AMENDMENT TO THE REVISED BIOLOGICAL ASSESSMENT FOR MONTANA DEPARTMENT OF TRANSPORTATION AND FEDERAL HIGHWAY ADMINISTRATION

NH 5-2(159)37; UPN: 8008000 US 93 Evaro to Polson (RP 6.8 to 59.0) July 30, 2020

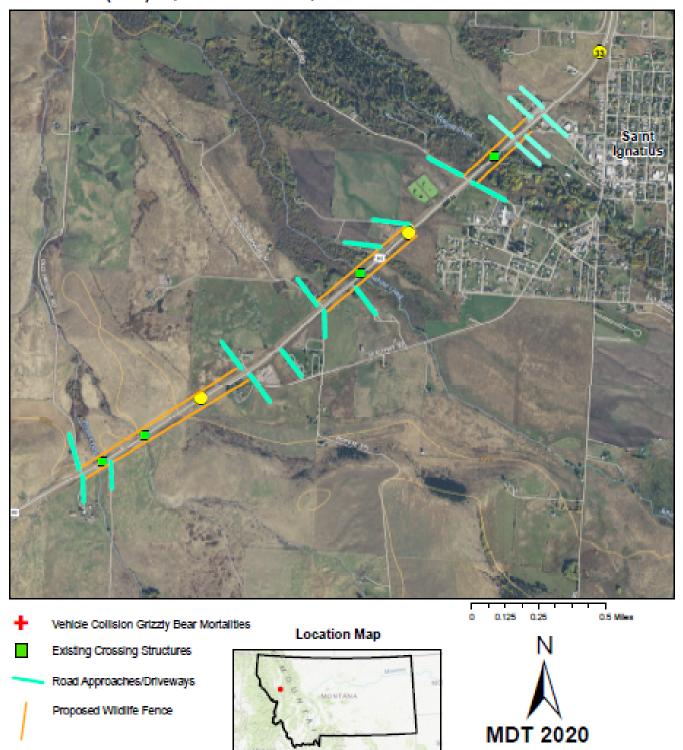
To address the need for additional guide fence at the existing mitigation structures north and south of St. Ignatius, Montana, FHWA and MDT have programmed and initiated the project NH 5-2(185)30, UPN 9828000, US 93 NORTH-WILDLIFE FENCING. During project scope development, it was determined that continuous fence, as proposed in the BA, would be cost prohibitive due to the high number of private and public road approaches that would require mitigation (i.e. electrified gates, electrified concrete/asphalt mats or other technology) and would greatly delay or completely prevent project implementation. Recognizing that grizzly bear-vehicle collision mitigation was urgently needed, an alternative design was decided upon that would construct fence to help guide grizzly bear and other wildlife to existing crossing structures. Each section of fence would end at points that did not encompass an un-fundable number of road approaches, would offer optimal driver site distance, and would utilize county road intersections where entering or exiting traffic would increase driver attention to the road ahead. The proposed project also reduces risk and potential project delays associated with right-of-way negotiations with adjacent landowners by keeping the fencing limits to areas with fewer approaches while meeting the expectation of the fence guiding grizzly bears to the

- Pistol Creek from Reference Point (RP) 30.40 to RP 30.93
 - No fence was built with these two structures.
- Sabine Creek from RP 31.60 to RP 32.06
 - o Short wing-fence was originally built with this structure.
- Mission Creek from RP 32.30 to 32.50 RP
 - Short wing-fence was originally built with this structure.
- Lower Mission/Lee from RP 33.60 to RP 34.84
 - Short wing-fence was originally built with three of the five structures. Two structures do not have wing-fence.

Wildlife jumpouts (escape ramps) will be incorporated into the longer sections of fence as appropriate.
